Access Compliance Report

Public Rights-of-Way

(Curb Ramps)

Intersection ID: N/A	Main Street: ELGIN_MOOR_RD	Cross Street: DOUGLAS_PALACE_CT	Location: SW
ADA ID: 10F449E5F3F3	Ramp Type: Perp	Initial Pass/Fail: Fail	Overall Compliance: No
		Severity Score: 12.5

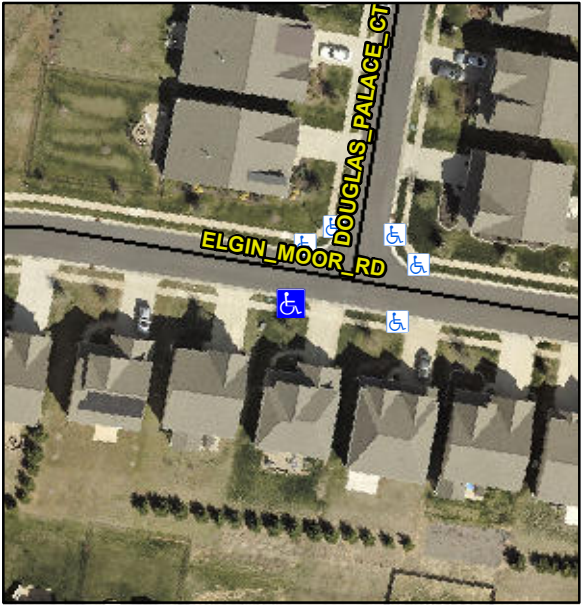
Codes/Mitigation Info/Possible Solution			Field Measurements/Component Compliance		
	Possible Solutions:		Compliance	Description	Data
	Remove & Replace Entire Ramp.		N/A	Ramp Length (in)	47.0
			Yes	Ramp Width (in)	48.0
			N/A	Flare Type LT	N/A
			N/A	Flare Slope LT (%)	N/A
			N/A	Flare Traversable LT?	N/A
			N/A	Landing Length (in)	N/A
			N/A	Landing Width (in)	N/A
			N/A	Landing Slope (%)	N/A
			N/A	Landing X Slope (%)	N/A
<p>Surveyor Notes:</p> <p>N/A</p> <p>PROW/ADA:</p> <p>R304.2.2</p>			N/A	Flare Type RT	N/A
			N/A	Flare Slope RT (%)	N/A
			N/A	Flare Traversable RT?	N/A
			N/A	DWS Provided?	N/A
			N/A	DWS Contrast?	N/A
			N/A	DWS Length (in)	N/A
			N/A	DWS Full Width?	N/A
			N/A	DWS Offset (in)	N/A
			N/A	Gutter Ponding?	N/A
			N/A	Gutter Lip Ht (in)	1.0
			N/A	Painted X Walk1?	No
				X Walk 1 Direction	To NE
			N/A	X Walk 1 Width (in)	N/A
				X Walk 1 Slope (%)	1.3
				X Walk 1 X Slope (%)	0.9
			N/A	Ramp inside XWalk1?	N/A

Road Slope (%)	N/A
				Road X Slope (%)	N/A
			N/A	Any Obstructions?	N/A
				Obstruction Type	
Total Cost:		\$ 1850.00			
			N/A		N/A
			Yes	Surface Condition? (G/P)	Good
